Entergy Nuclear Northeast  
Entergy Nuclear Operations, Inc.  
Indian Point Energy Center  
295 Broadway, Suite 1  
P.O. Box 249  
Buchanan, NY 10511-0249

Re: Indian Point Unit No. 2  
Docket No. 50-247  
NL-03-137

**Subject:** Supplement 7 to the Indian Point 2 License Amendment Request for Conversion to Improved Standard Technical Specifications

Table 3.5-1

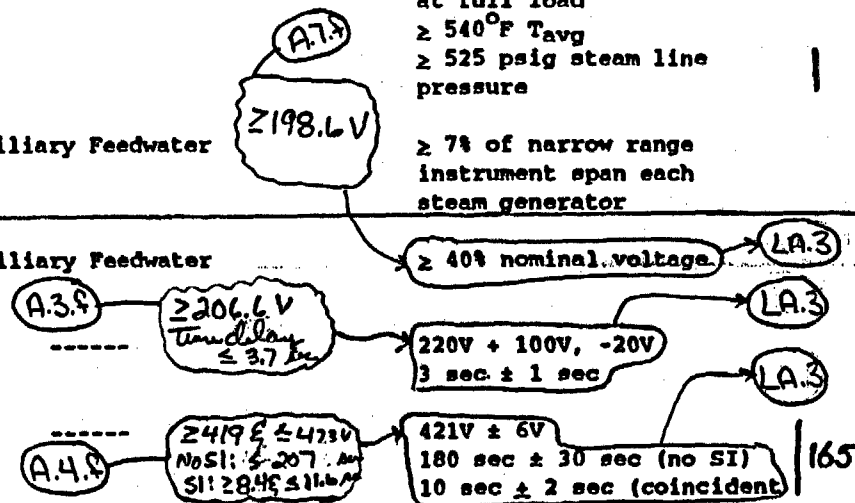
SEE  
ITS 3.3.2
